Bottom (CTCSS, Carrier Delay Time and Time Out Timer)

File: RepeaterController.sch

Title: Repeater Controller for NEUTEC 1630

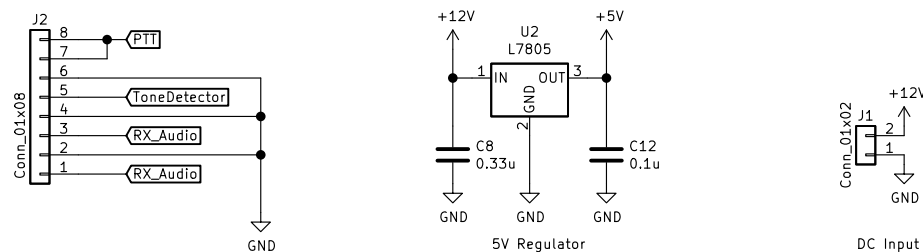
- MISSING:
- Range for Tone detector 67 - 254Hz (Resistor range verify - test)
 - 7805 Capacitors check
 - CHECK 330p pads at 5mm Caps (C10 done)
 - DC IN - Molex 3pin (Check cable)
 - Relay pads should be larger
 - C3 has polarity as tantalum... maybe polyester? pad size
